SUBJECT: DOCUMENTS ASSOCIATED WITH NRC GENERIC LETTER 97-01,
DEGRADATION OF CONTROL ROD DRIVE MECHANISM AND OTHER VESSEL
CLOSURE HEAD PENETRATIONS (TAC No. M95280)

NRC GENERIC LETTER 97-01: DEGRADATION OF CONTROL ROD DRIVE MECHANISM
NOZZLE AND OTHER VESSEL CLOSURE HEAD
PENETRATIONS

SUBJECT: PROPOSED NRC GENERIC LETTER: "DEGRADATION OF CONTROL ROD DRIVE MECHANISM AND OTHER VESSEL CLOSURE HEAD PENETRATIONS"

Figure 1. Typical control rod drive mechanism nozzle.
Copyright the Minerals, Metals & Materials Society; reprinted with permission.

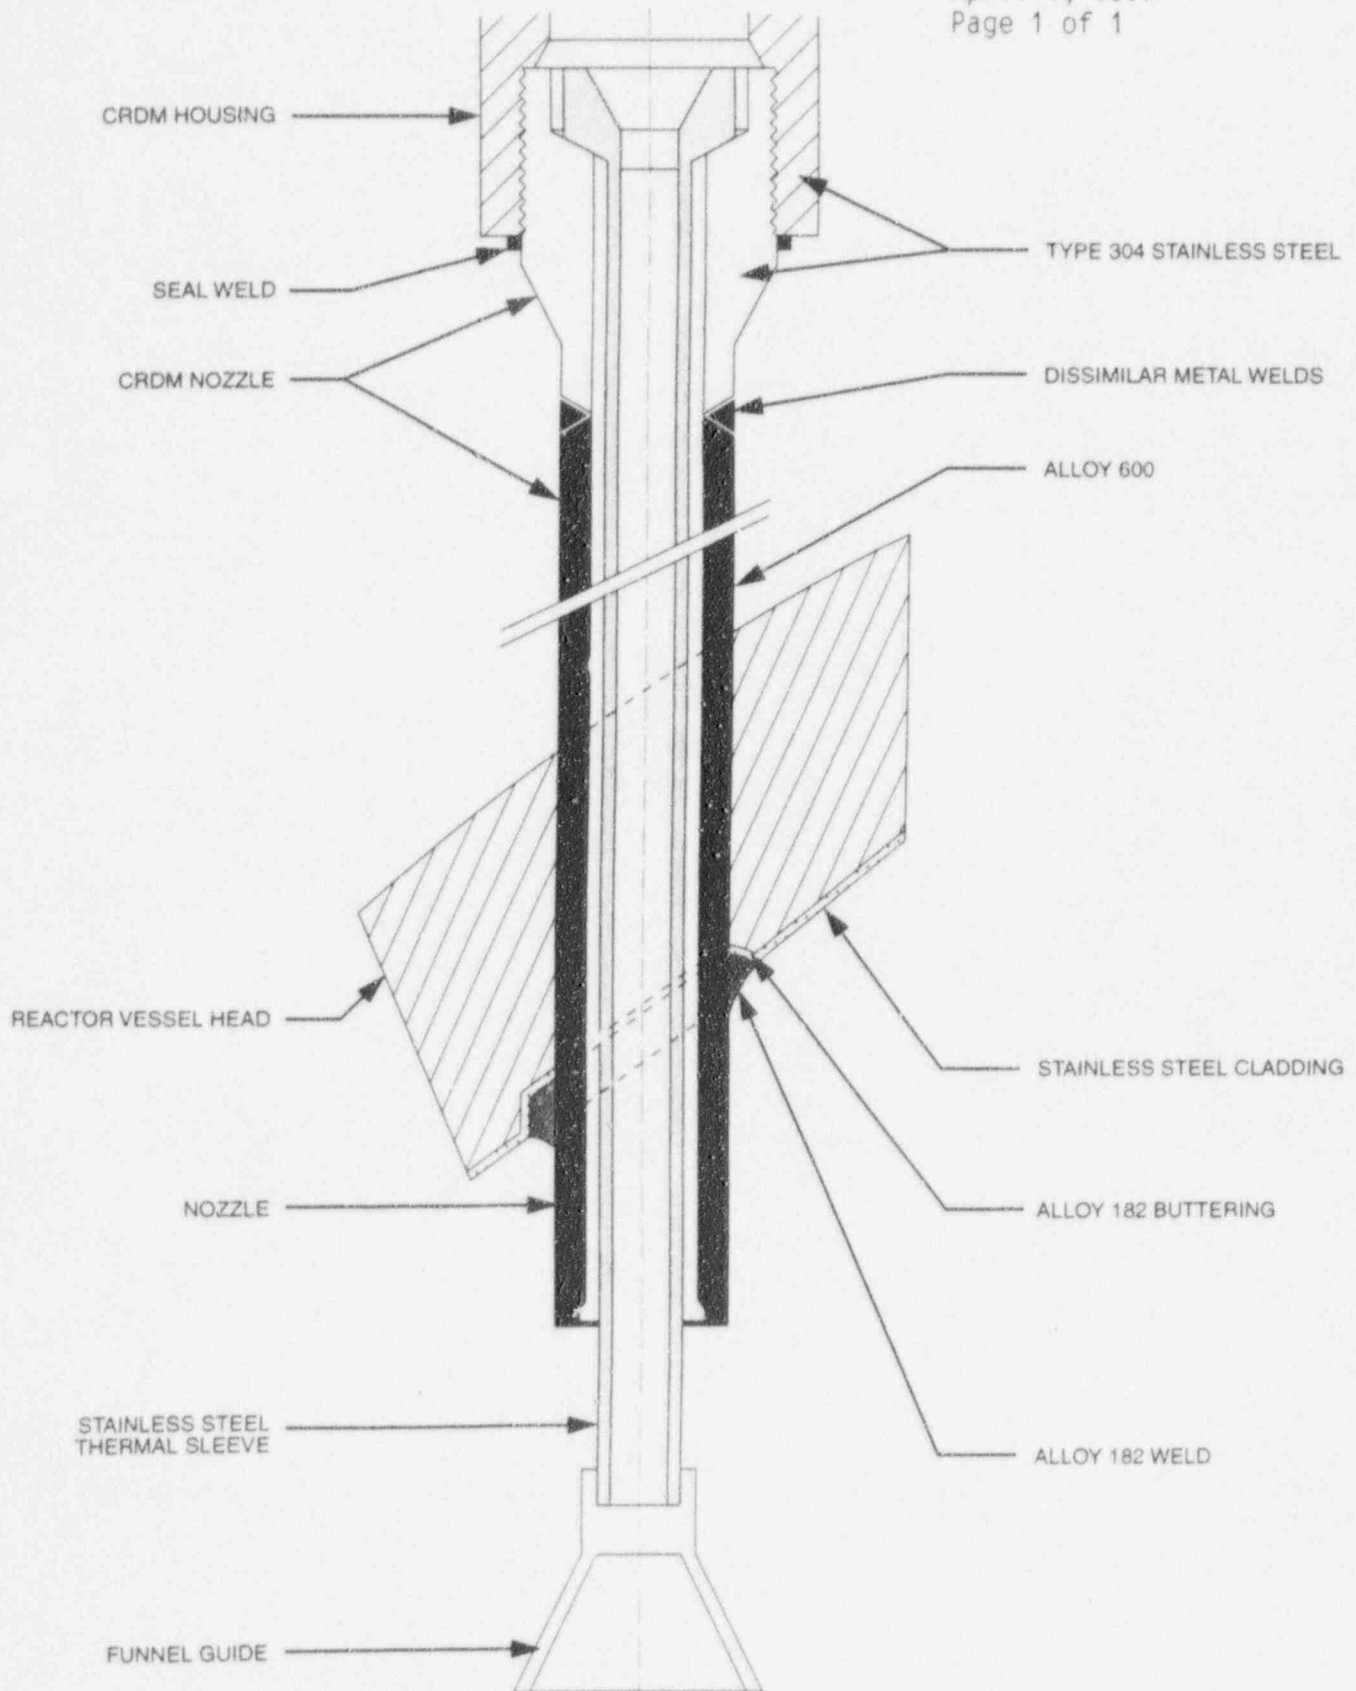
3.	Background	1st	Figure 1 and text appear to only discuss CRDMs designed by Westinghouse.	A description of the CE and B&W penetration design features would be beneficial.
